Comments on the Second Project Design Document and Application for Validation after Rejection of Registration by CDM Executive Board

GHG Emission Reductions through grid connected high efficiency power generation, Coastal Gujarat Power Ltd., India

July 12, 2011

Selected Steam Coal Prices 2001-2008

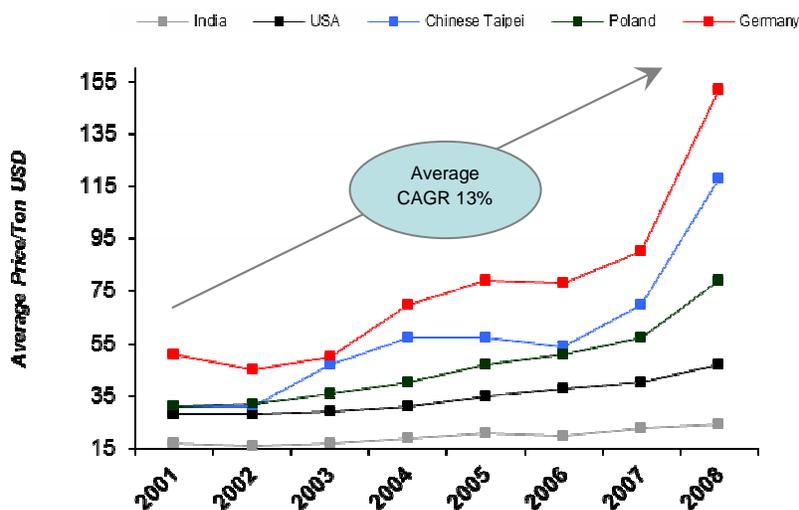
Sector analysts have warned that Asian coal markets, including India, are increasingly subject to greater price volatility due to surging demand and a high correlation with oil prices.⁶⁹ Rising and volatile coal prices will squeeze plant operator profit margins. The cost of fuel inputs can account for 40-60 percent of the total cost of generation.⁷⁰ Variable costs in Maharashtra, for example, are as high as 2.2 cents/kwh.⁷¹
